Ord River Dam hydro power project

**An addendum to proposed changes to environmental
conditions**

**Report and recommendations
of the Environmental Protection Authority**

**Environmental Protection Authority
Perth, Western Australia
Bulletin 759
October 1994**

FIGURE 1

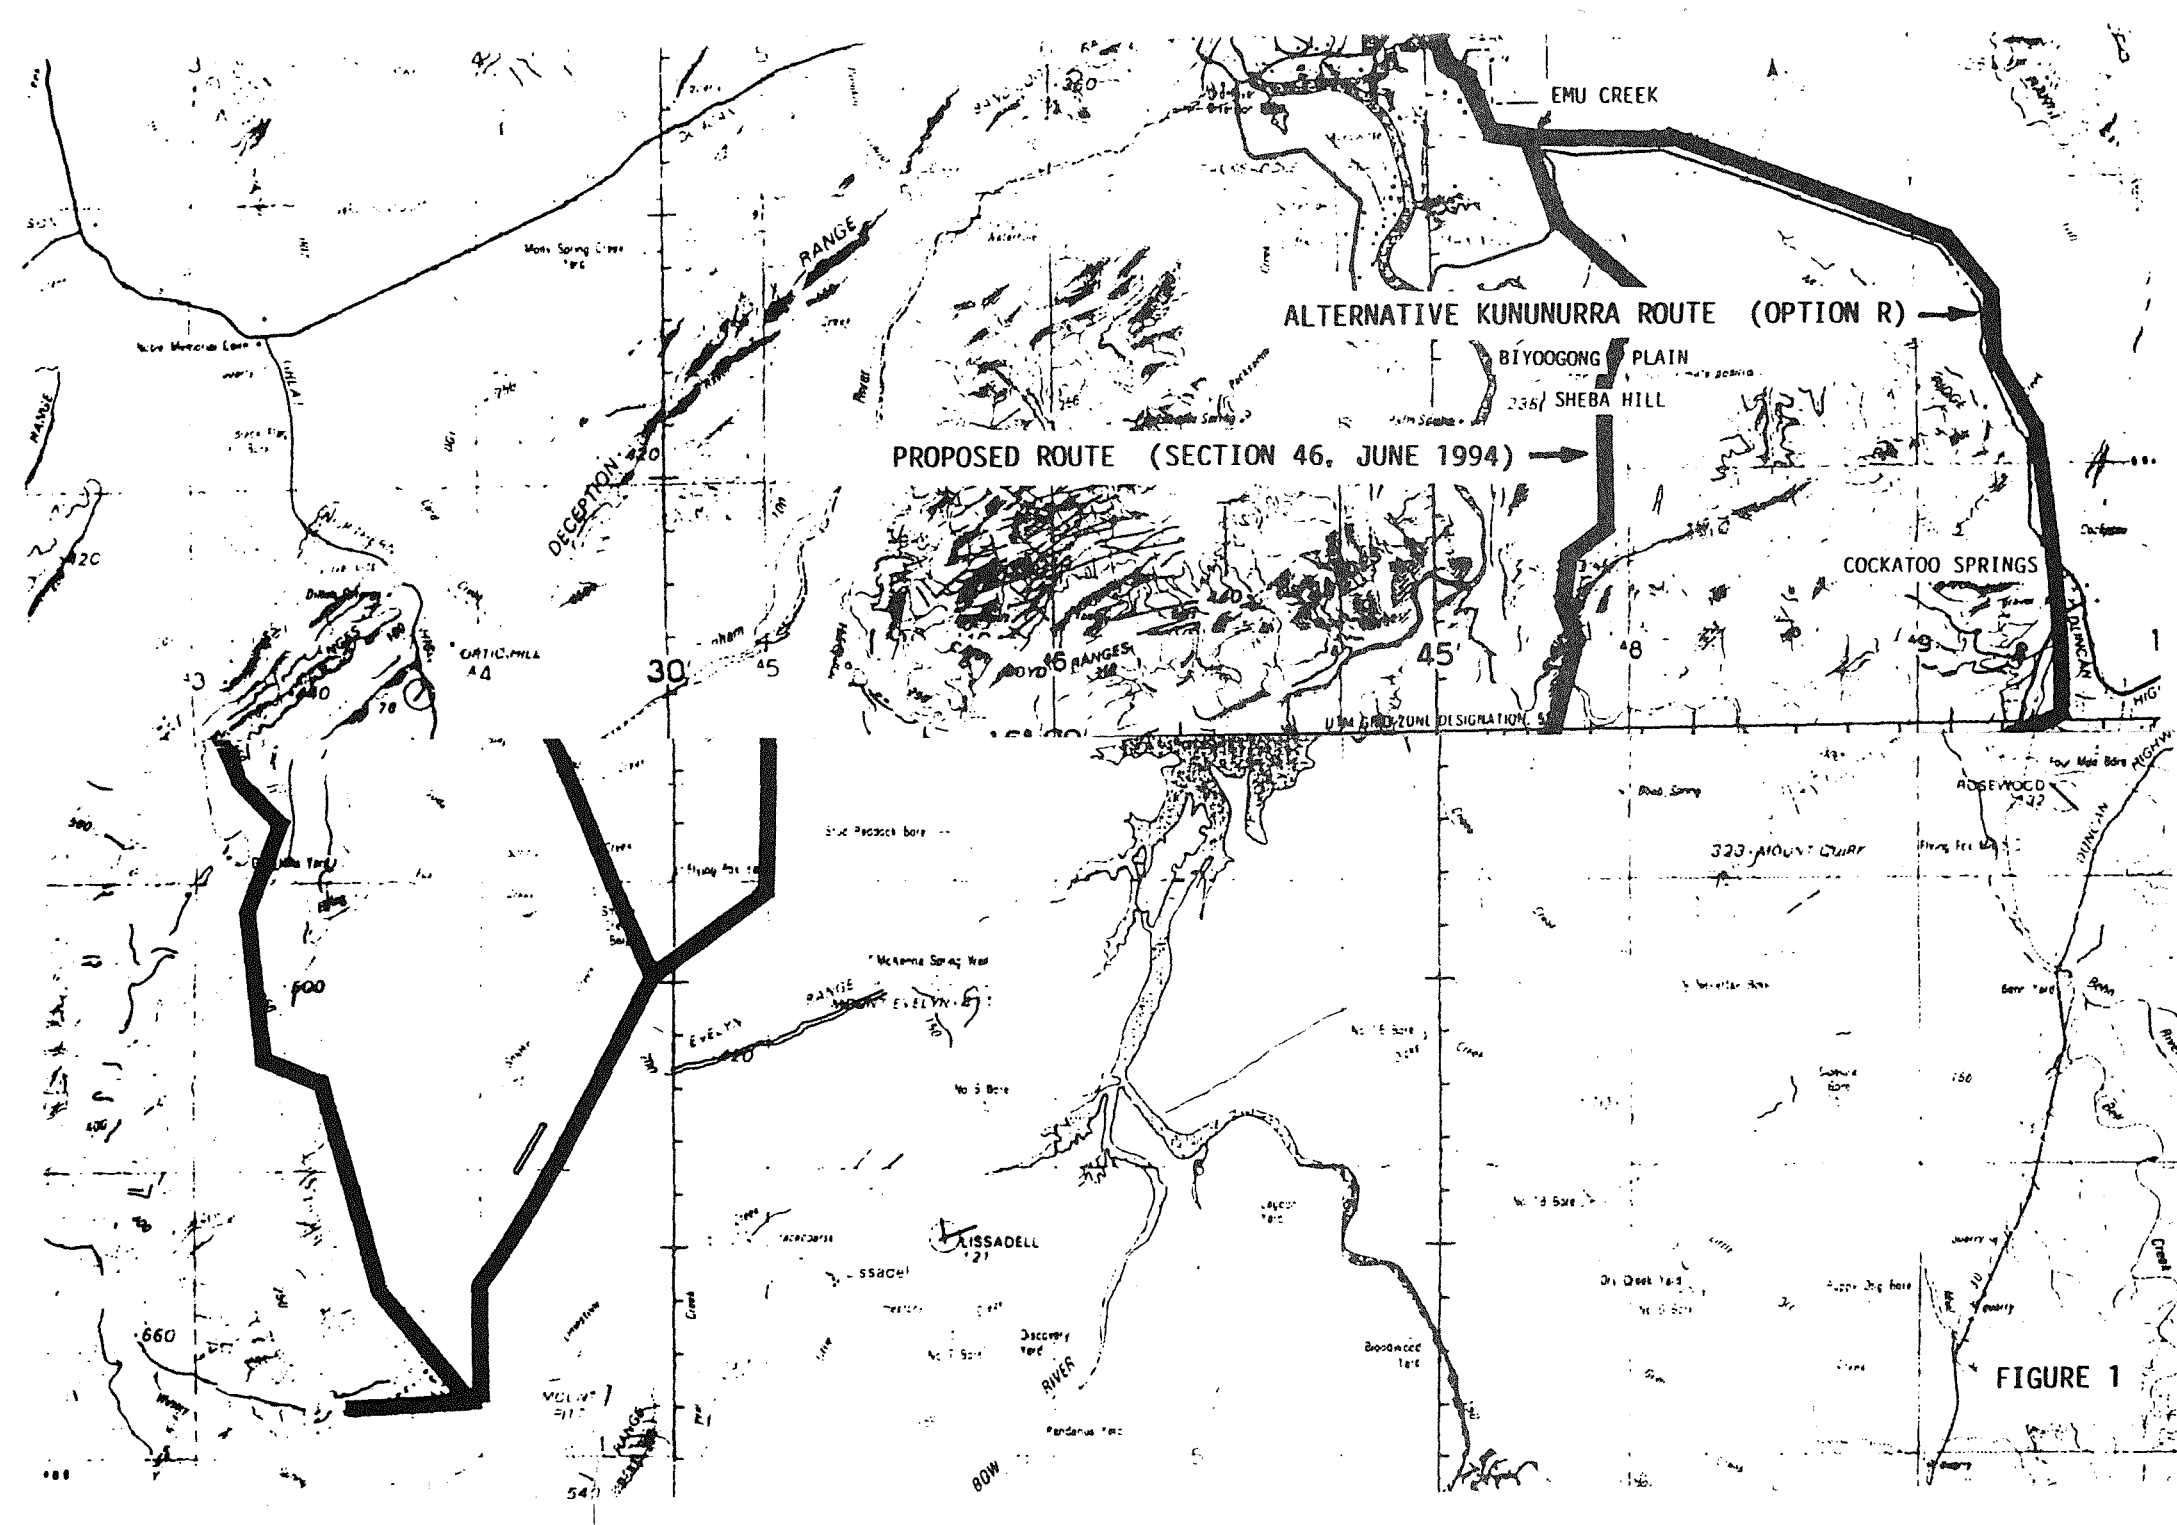
The key environmental concern with regard to this proposed transmission route is visual amenity. The transmission line is likely be visible by those using the two roads and impact adversely on views of the surrounding countryside and perceived naturalness and tranquillity of the area. The route has the advantage that it is easily accessible given the existing road infrastructure.

The principal matter of environmental concern is that this proposed transmission route will traverse the proposed Carr Boyd National Park. This raises issues of protection of the park from physical incursions and degradation, as well as protection of flora and fauna, the wilderness aspects and the visual amenity. The route also has the potential to impinge on tourist operations.

As with Option P, the principal matter of environmental concern is that this proposed transmission route will traverse the proposed Carr Boyd National Park. This raises issues of protection of the park from physical incursions and degradation, as well as protection of flora and fauna, the wilderness aspects and the visual amenity. Other issues of concern to the Authority include access difficulties given sections of rugged terrain and the fact that detailed investigation of the route has not been undertaken.

The Authority considers that this route would be environmentally acceptable subject to compliance with commitments and environmental conditions.

The Authority considers that this route would be environmentally acceptable subject to compliance with commitments and environmental conditions.

The Authority does not consider this route to be environmentally acceptable.

Figure 2: Proposed Lake Argyle and Carr Boyd Range National Park

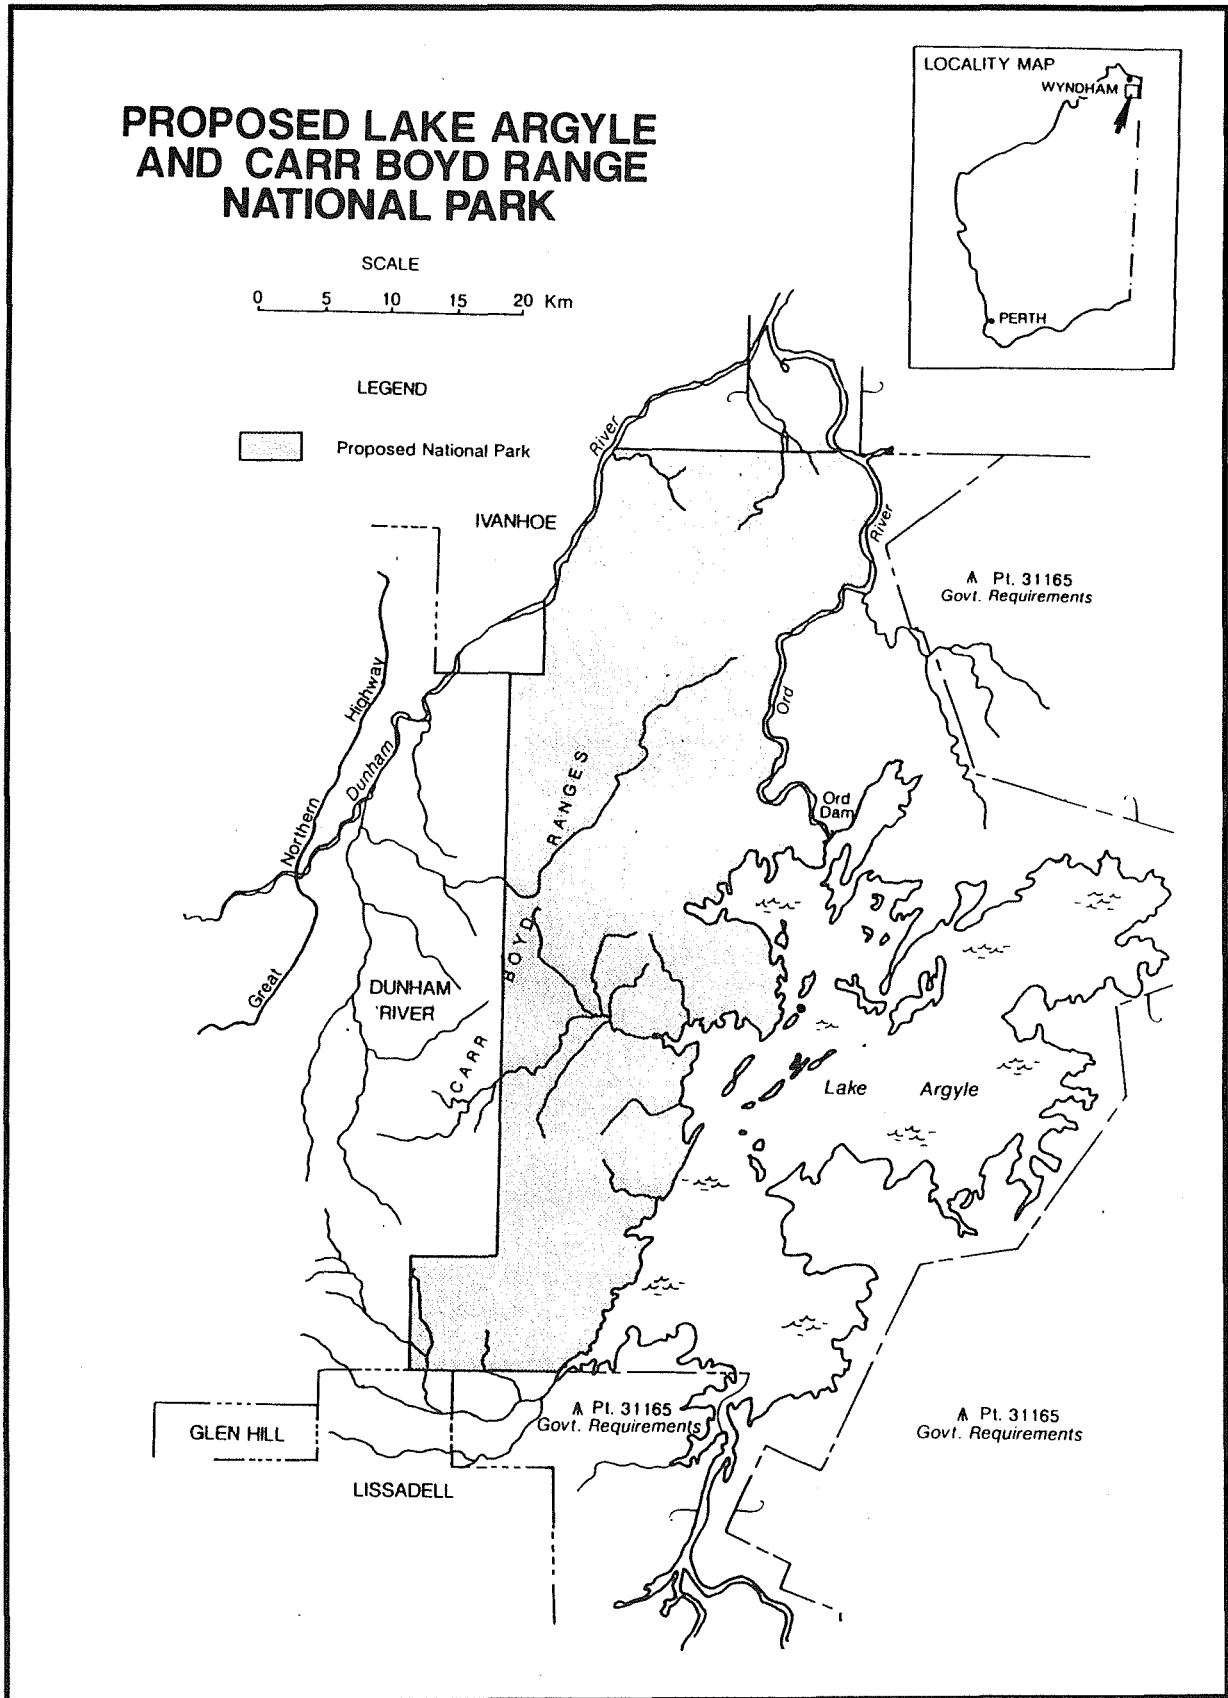
This alternative shoreline route predominantly follows the eastern boundary of the proposed Carr-Boyd National Park for approximately 50km (Blandford & Associates, 1994). The proposed Lake Argyle and Carr Boyd Range National Park which was recommended by the EPA in 1980 as part of its System 7 report (EPA, 1980) is shown in Figure 2 (CALM, 1991).

This alternative shoreline route passes through the proposed Carr-Boyd National Park for approximately 30km (Blandford & Associates, 1994 b).

Revolver Creek crossing

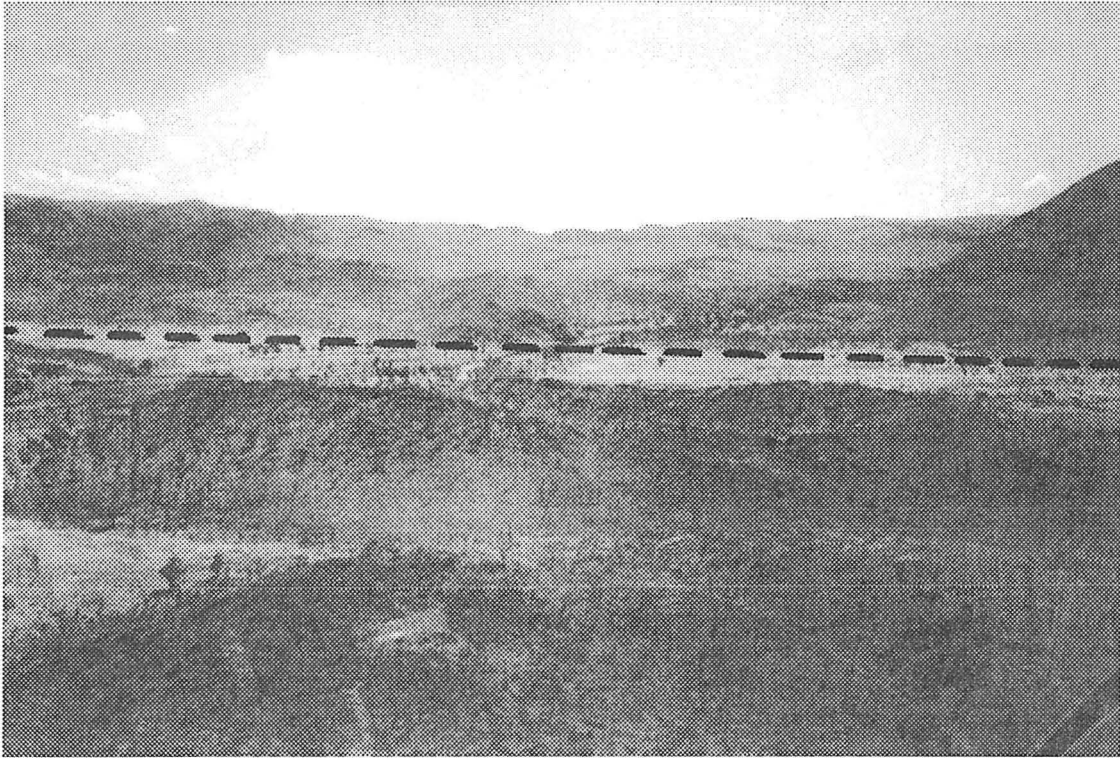
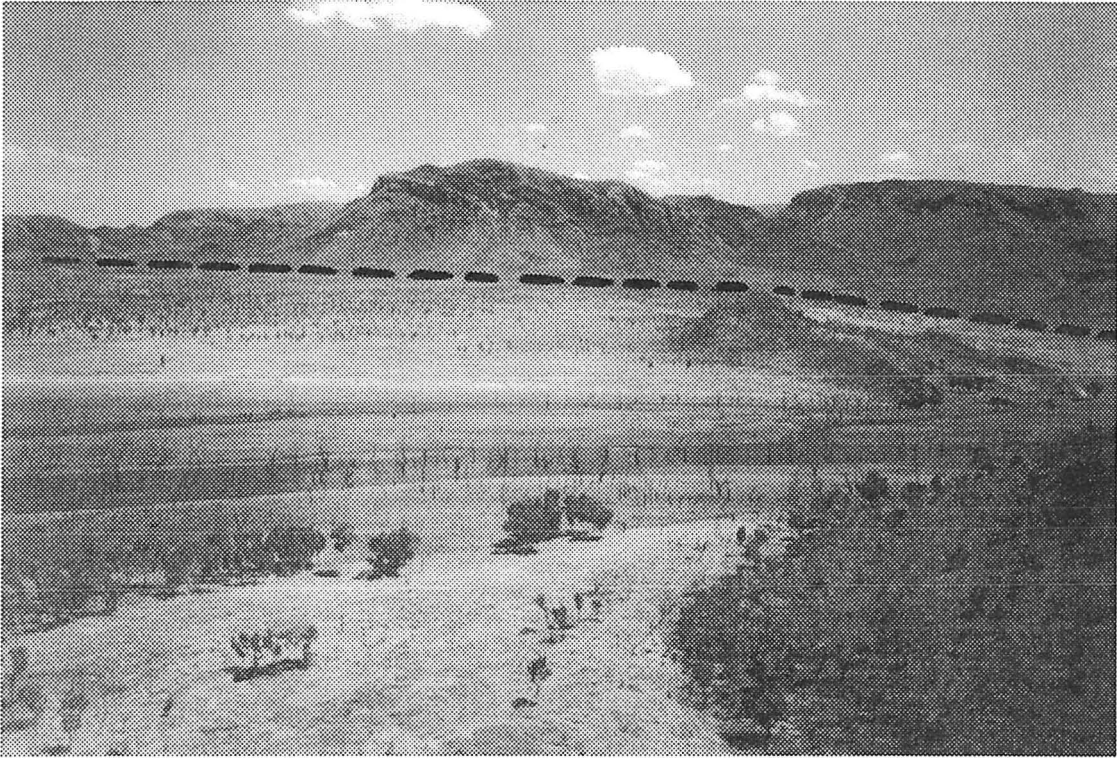
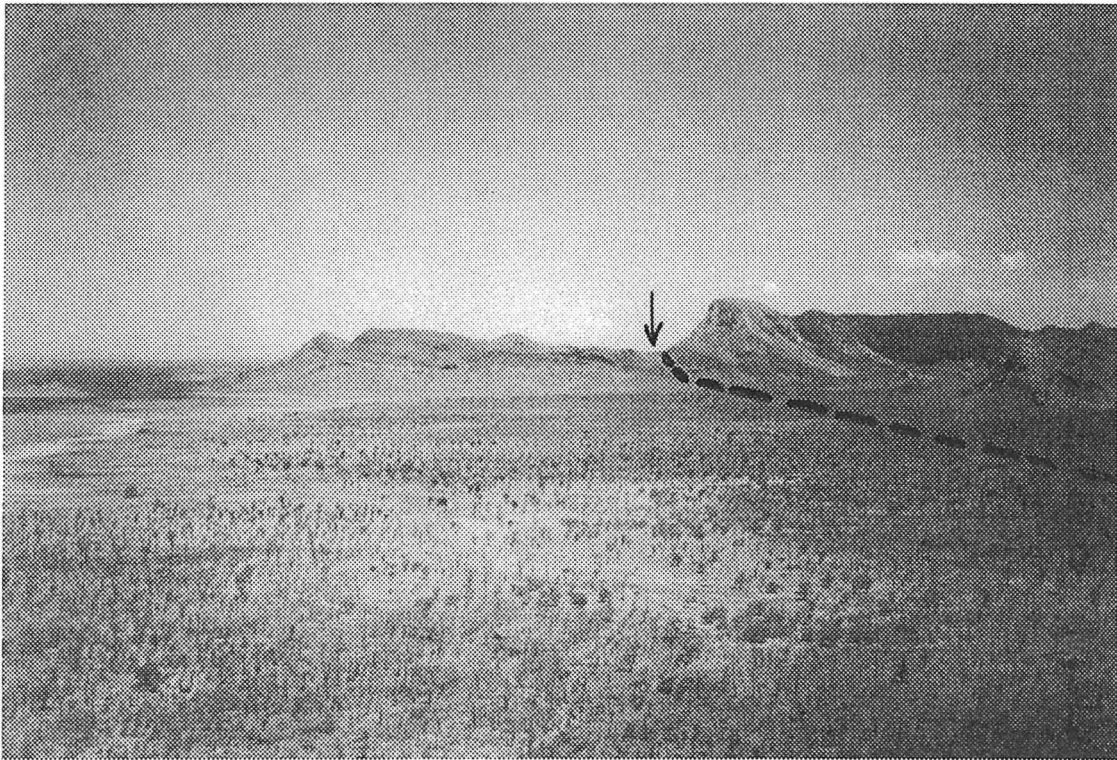
The attached Plates 11 and 12 show the terrain crossing Revolver Creek in more detail with the proposed line route sketched in. It should be noted that the Lake level is currently at about 87 metres which is the long term average level.
